## Community proposals for the Westlake Cycle Track and SDOT responses

Nov. 18, 2014

### Overview

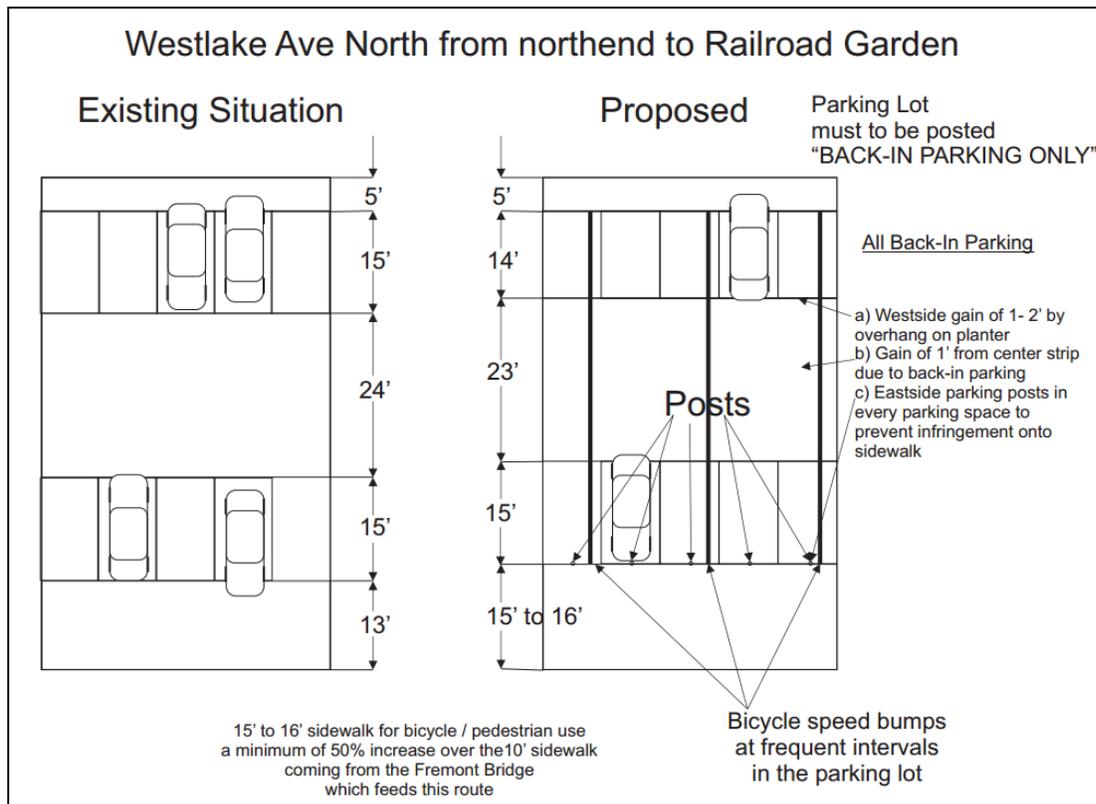
From the Fremont Bridge to the north entrance of the Westlake Ave North parking lot, there is a 10' wide sidewalk that accommodates the flow of bicycle and pedestrian traffic. This has not been a conflictive area as far as accidents between these two transportation modes.

We are proposing this theme be continued in the parking lot until the "Railroad Garden" with an additional 50% in width to the sidewalk. This sector of the corridor does not have a service lane which could be converted to a protected cycle lane. Even a 5% loss of parking would threaten the businesses in this sector with a loss of revenue that would create a catastrophic domino effect. The city's own norms call for 1 parking space per every 2 boat slips adjacent to marinas; this does not take into account additional businesses or liveaboards. We are already at or below this norm. The historic conflict in this sector has been between high speed cyclists & cars, cyclists that ride close to the parked cars and the cars exiting parking spaces, or pedestrians & cyclists in the parking lot. (Cyclists on the side walk give way to pedestrians.)

For this reason, measures such as bike bumps the full width of the parking lot are an important part of any discussion about safety.

- Project staff met with Jack Wilken to discuss his proposal.
- SDOT analyzed some of the advantages of the concept including:
  - Retains perpendicular parking and maximizes parking supply

- Back-in parking better accommodates vehicle overhang and increases visibility
- SDOT also analyzed some of the challenges of the concept including:
  - Currently many truck drivers with larger vehicles back into parking spaces on the west side of the parking area to take advantage of the landscape buffer for vehicle overhang

- Need to maintain existing planting strip width adjacent to Westlake to accommodate vehicle overhang (see photo below)
  - 15-16' sidewalk may not be wide enough to accommodate bicycles and pedestrians

- Lack of space and separation from pedestrians may shift bicyclists into the parking area; the sidewalk connecting to Fremont Bridge functions adequately as all travel by pedestrians and bicyclists is parallel to the sidewalk, that is there is no cross pedestrian traffic as in the business, marina, residential areas in the corridor.

- SDOT did incorporate speed bumps in the drive aisle into the cycle track alignment.
- SDOT will work with the community to identify possible constrained areas where narrowing and shortening parking stalls may be appropriate.

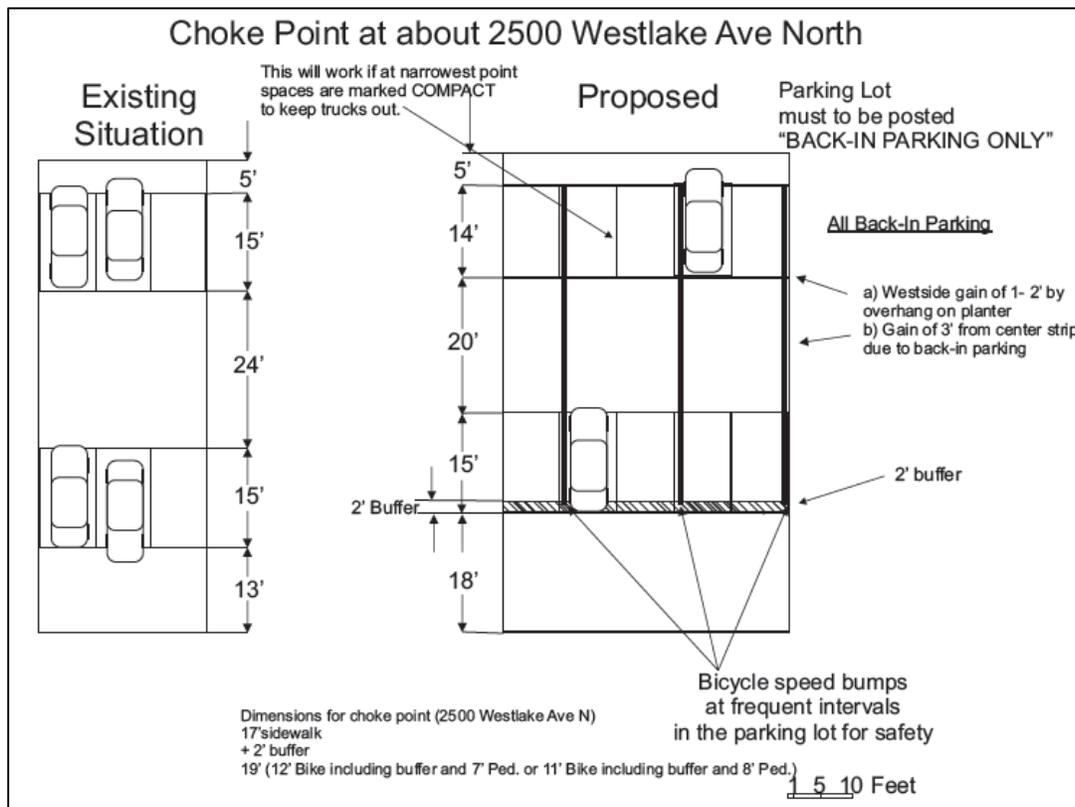
Anyhow, given that you have a plan before you (see attachment) that saves essentially 100 percent of the parking and delivers a world-class cycle track, what is preventing the city from advancing it? This is the plan that was shared with Sam and James last week (and CJ) as well as Sen. Kohl-Welles when I met with her last Thursday.

The bicycle community would get their dedicated track; pedestrians would have predictability and the marine community would not lose parking. Even more, this design was put together after several drafts, incorporating the feedback from the SDOT team all along the way.

Sorry for the delay in responding to your email. As you mention, staff has talked with you and Jack about the proposal you emailed. I see adjustments to the sidewalk and drive aisle widths from previous versions and really appreciate this type of collaboration.

- 17 feet does not meet the cycle track design guidelines for accommodating bicycles and pedestrians (minimum eight feet for the sidewalk and 10 foot with two foot buffer for the cycle track). Lack of space and separation from pedestrians could shift bicyclists back into the parking area
- We've incorporated the suggestion of adding speed humps in the drive aisle
- We're considering back-end parking
- We'll work with the community to identify constrained areas where narrowing parking stalls may be appropriate.

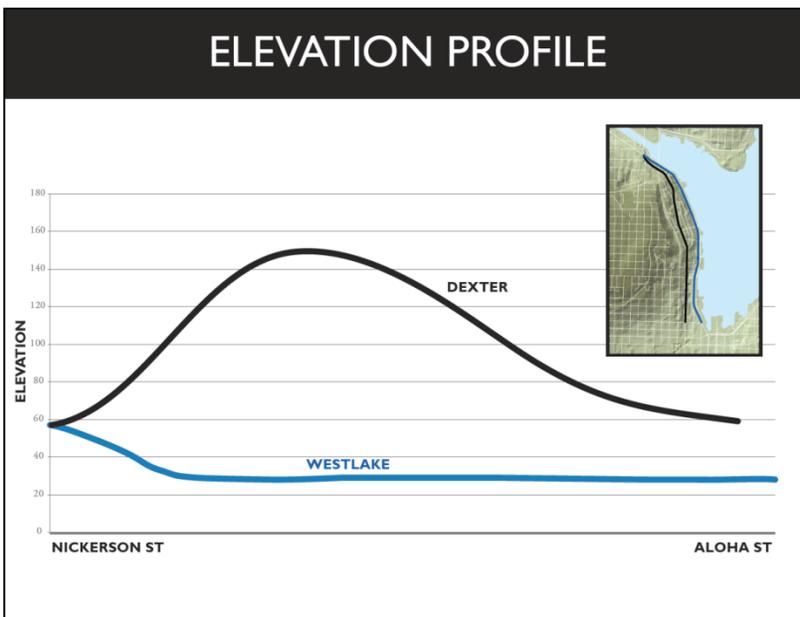
Separate the cycle pathway into two lanes: a northbound lane and a southbound lane. The northbound lane would be taken from the current 14 foot-wide sidewalk (along the water) and the southbound lane would be a shared lane with pedestrians on the expanded sidewalk on the west side (hillside) of Westlake Avenue North. Now, the northbound component on the eastside of the Westlake parking lot has and is being vetted as part of the ESC. The new part of this concept is the use of the four foot

sidewalk plus two foot planting strip to create a six foot wide bike pathway to be shared with maybe 10-20 pedestrians per day.

The design team has looked at your proposal to split the cycle track directions between the roadway and parking area. As you identified in your email, the concept requires very few changes from the existing conditions in an attempt to reduce the overall footprint of the cycle track and therefore maximizes parking and preserving the existing landscaping. The design team identified the following issues with the proposal:

- The condition is very similar to what exists today – which has issues that the design team is working to address
- The southbound bicycle facility (which in your proposal is a shared 6' wide sidewalk) does not meet the project goals and objectives.

- The southbound bicycle facility may not be used by bicyclists as it would be less attractive and convenient than riding in the parking area – many cyclists destined for South Lake Union or on recreational rides will not cross Westlake Ave N and instead will stay in the parking area.

- This would require additional crossings of Westlake Avenue North which has an impact on traffic mobility on Westlake Ave N.
- There are encroachments in the right-of-way on the west side of Westlake Ave N that would have to be removed.

- Further south, there is development up to the right-of-way line creating conflicts.
- There are pedestrian conflicts on the west side sidewalk – the sidewalk is more heavily used at the south end of the corridor.

- Motorists and pedestrians may not anticipate bicycle traffic on the constrained sidewalk.
- There are utility conflicts in the sidewalk, not only limited to fire hydrants, but street light poles.

- There are other areas of unstable hill side along the west side creating challenges to maintaining the existing sidewalk.

- A buffer would be required between the curb travel lane and the bicycle facility.

The project team is moving forward with the Sidewalk Concept and will continue to work with the community to best accommodate everyone's needs. The Sidewalk Concept aims to preserve about 80% of the parking in the corridor and SDOT is including parking management as part of the project in order to make better use of the existing parking.
